ADDENDUM
NO. 2

October 31, 2023

HANOVER COMMUNITY SCHOOLS - JANE BALL ELEMENTARY RENOVATIONS AND HIGH SCHOOL IMPROVEMENTS

SHEET AD101

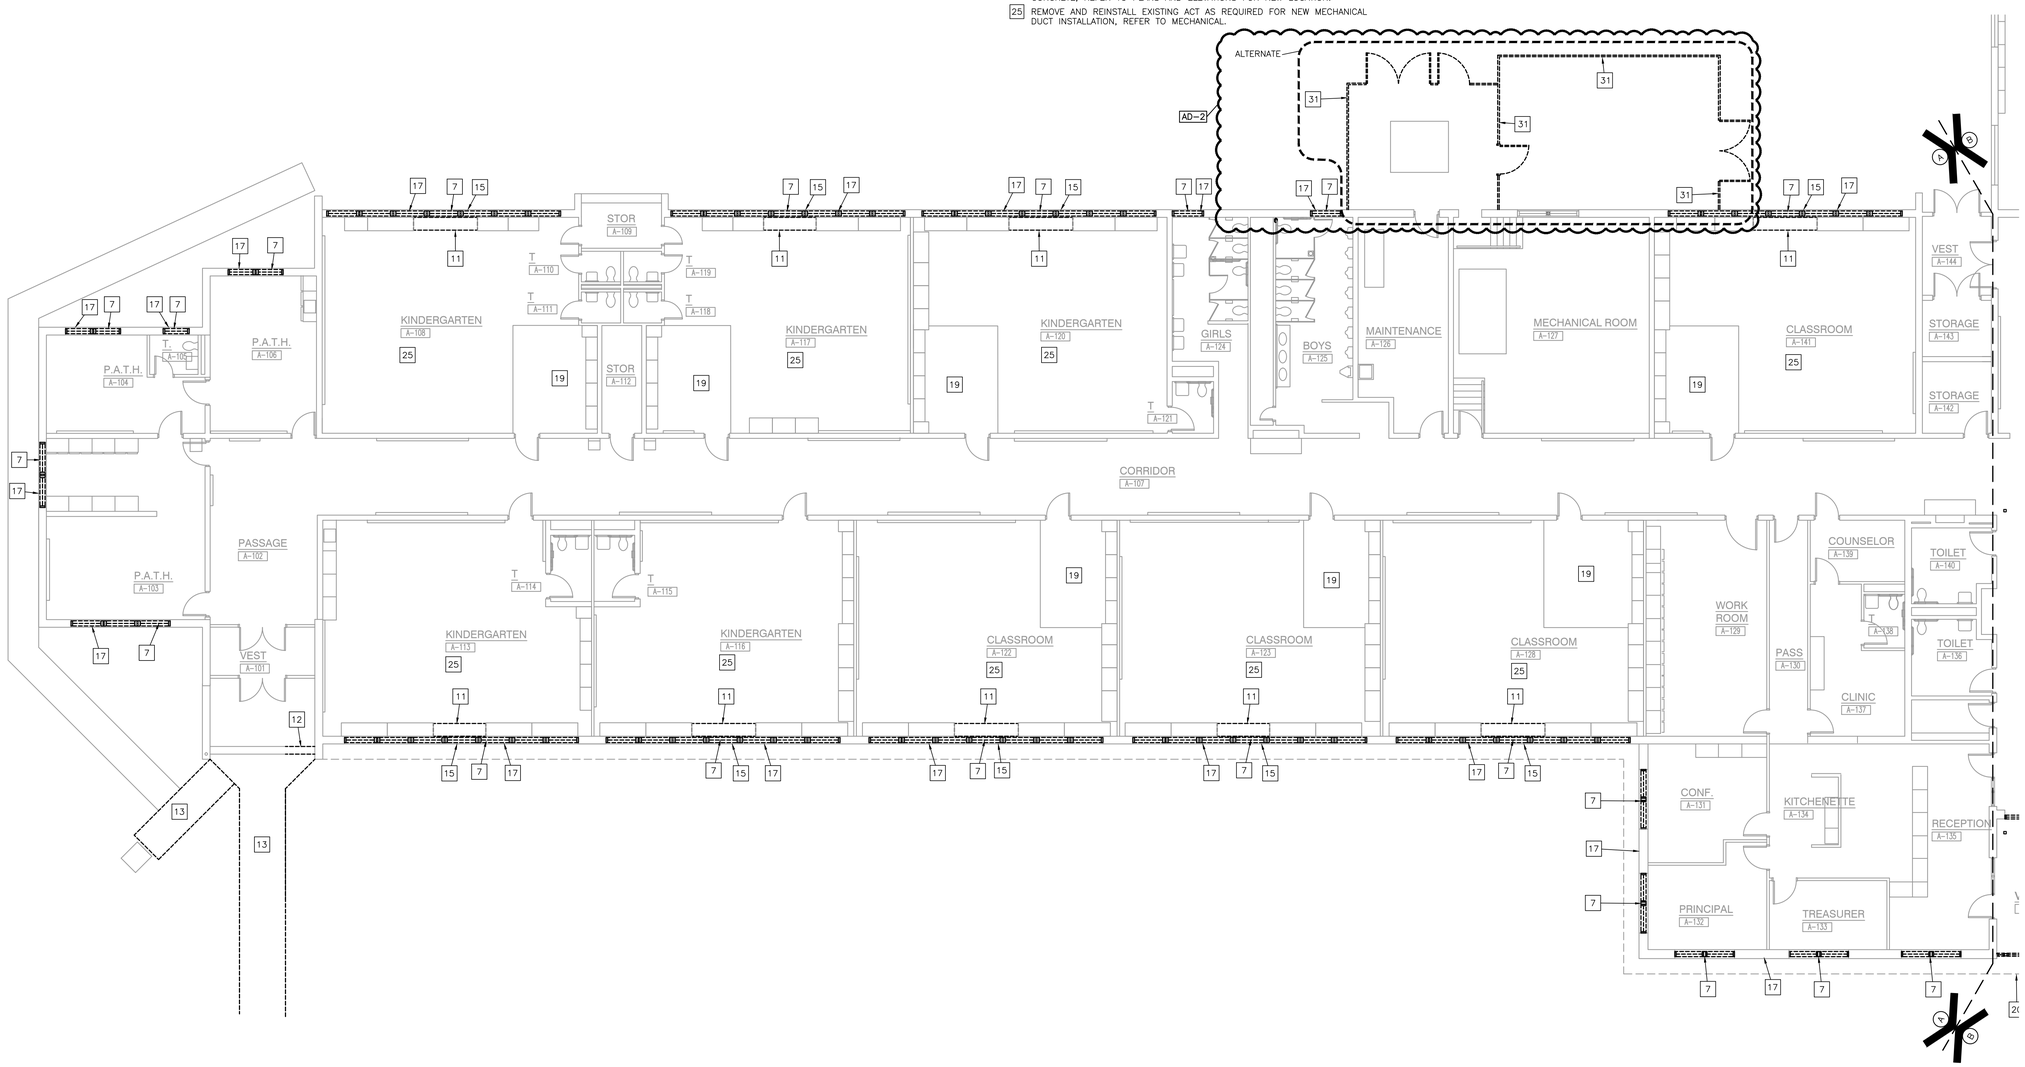
1. Add demolition plan notes 28-31
2. Added Alternate to demo existing mechanical/electrical yard fencing.

SHEET AD102

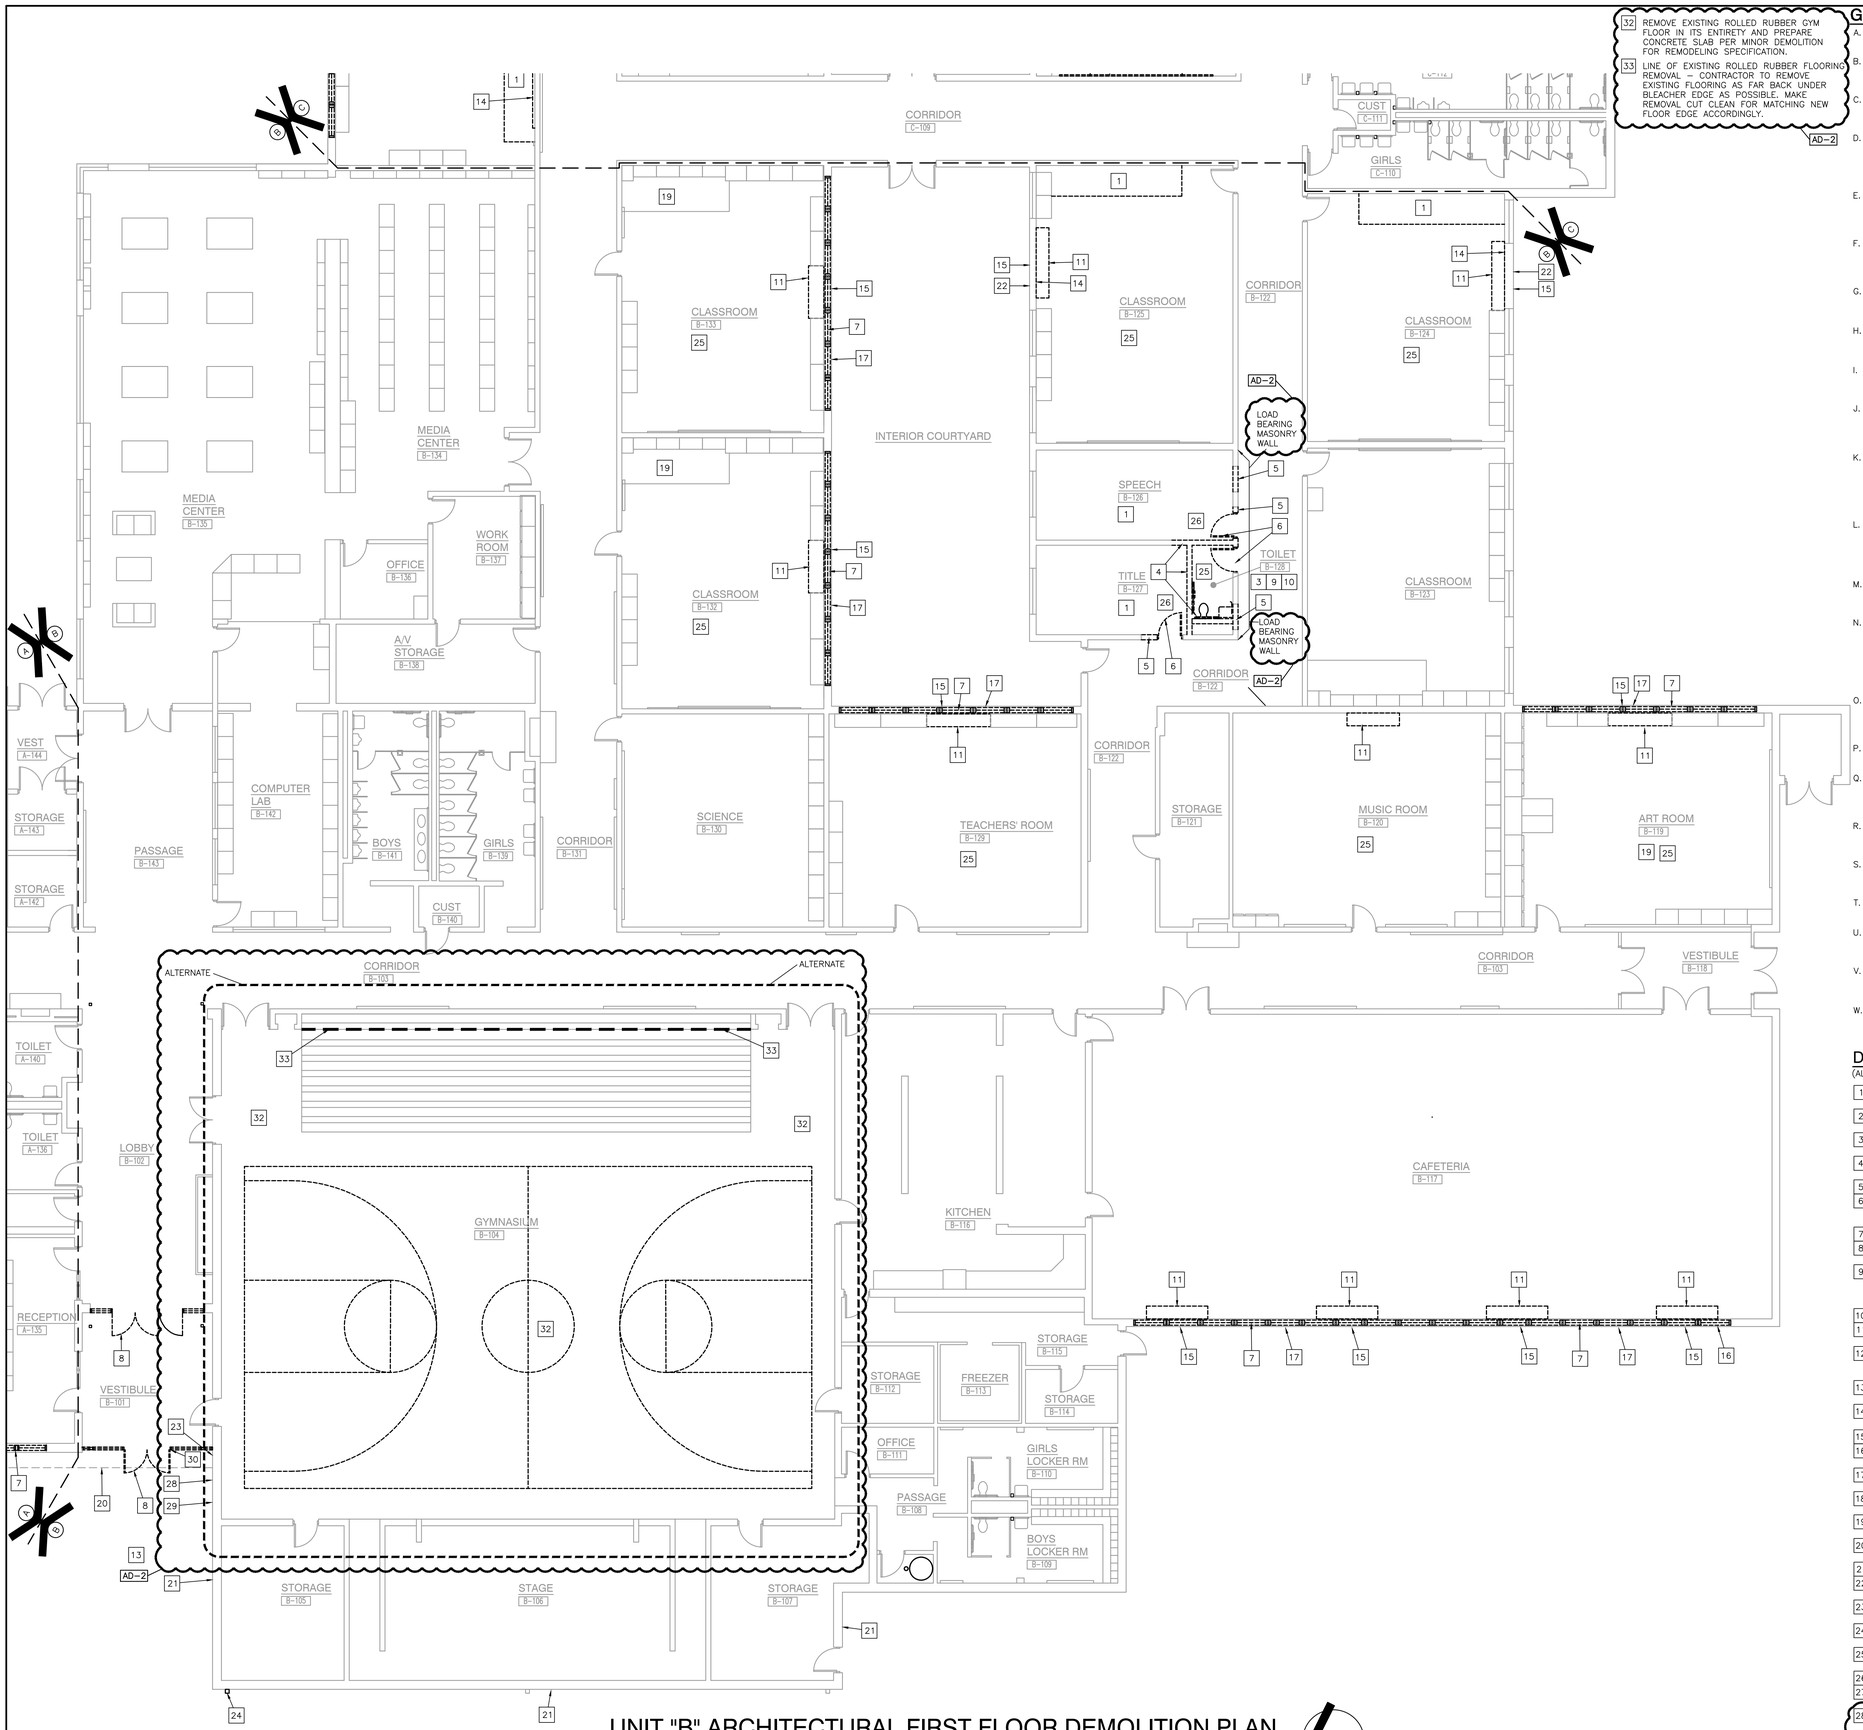
1. Add demolition plan notes 28-33
2. Add plan notes 28 and 29 outside of main entrance.
3. Added notes to denote where there is a load bearing wall where construction is taking place.
4. Added alternate to demo existing gym floor and prepare it for new.

SHEET
A-101

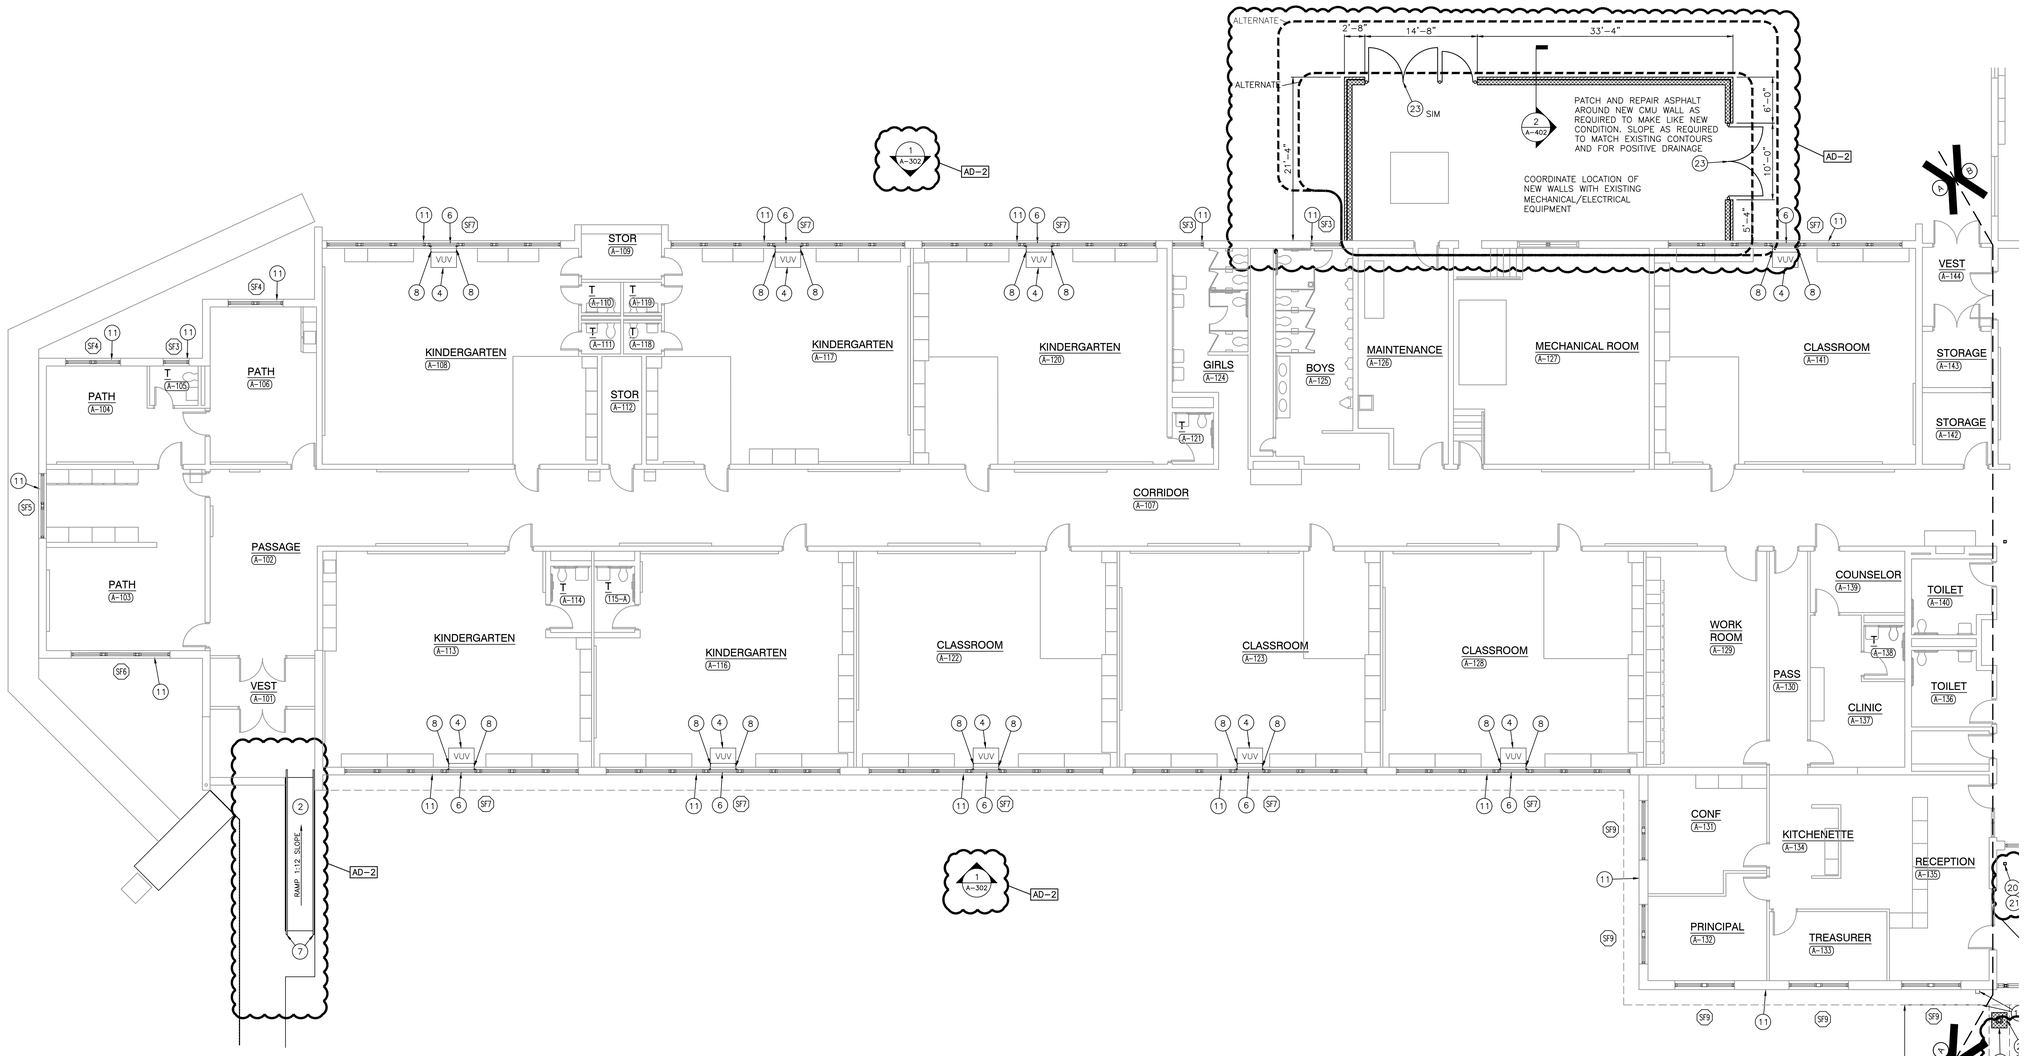
1. Revise Plan note 22 and add plan notes 23-24.
2. Remove ramp dimensions, refer to Civil.
3. Add elevation callouts.
4. Add alternate for new masonry mechanical yard wall with gates.

SHEET A-102

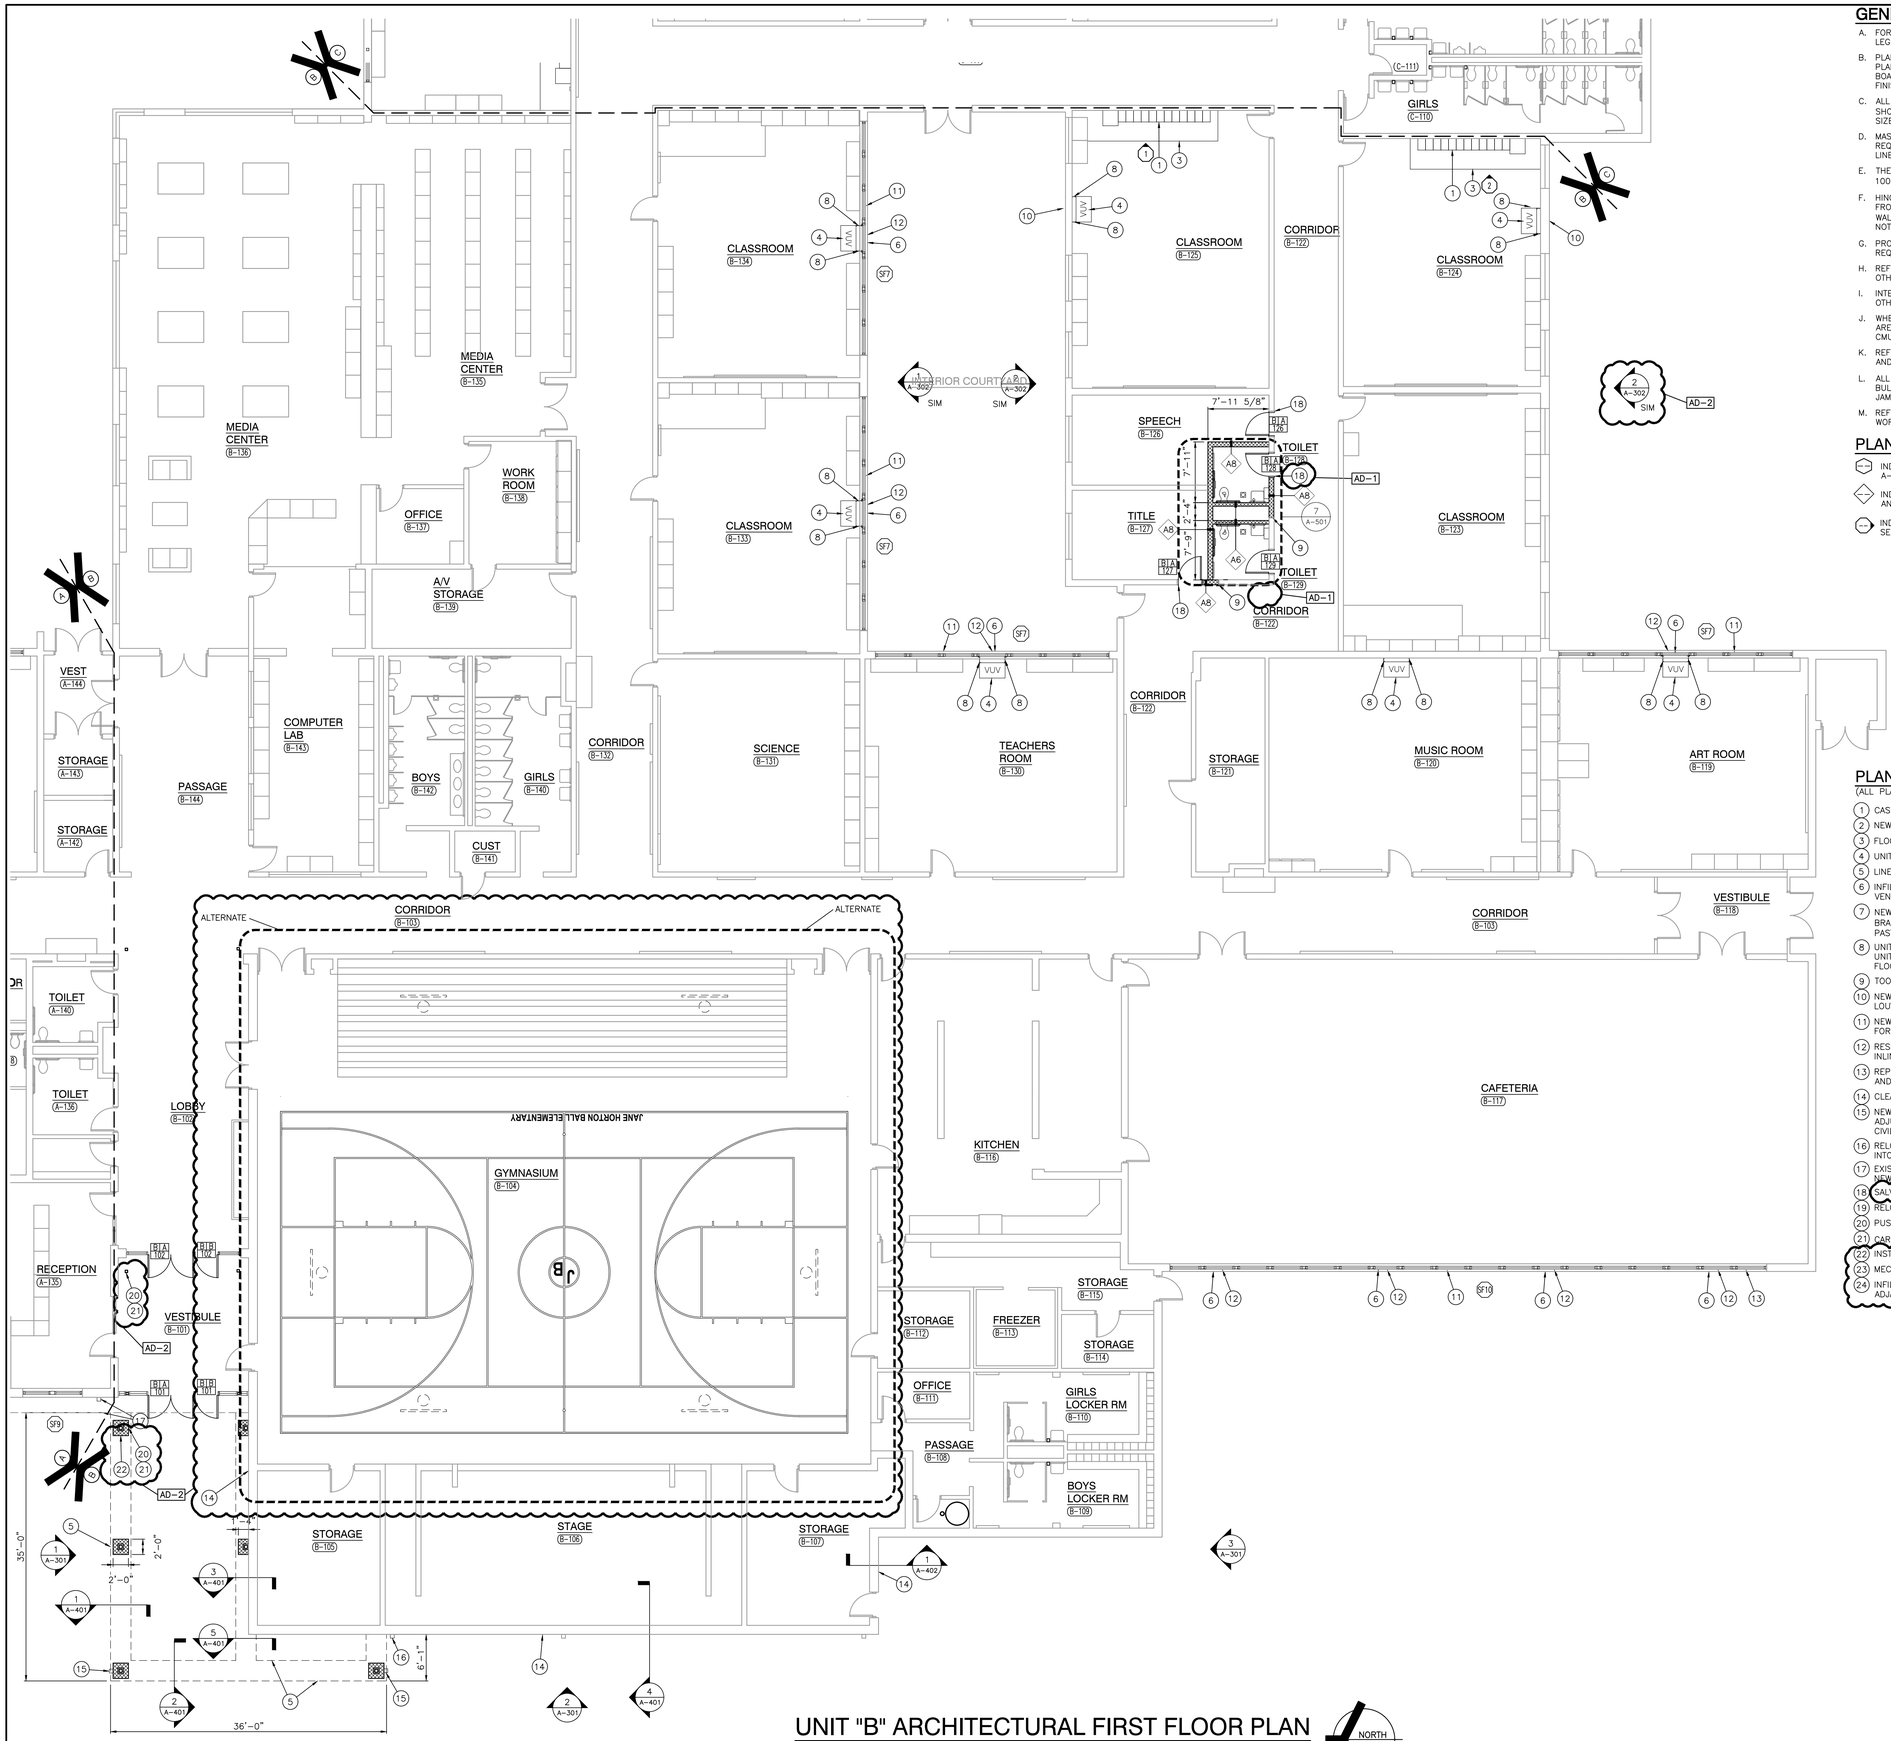
1. Revise Plan note 22 and add plan notes 23-24.
2. Add elevation callouts.
3. Revise location of Knox Box, card readers, and ADA push pads at the front entrance.
4. Added alternate for new gym floor.
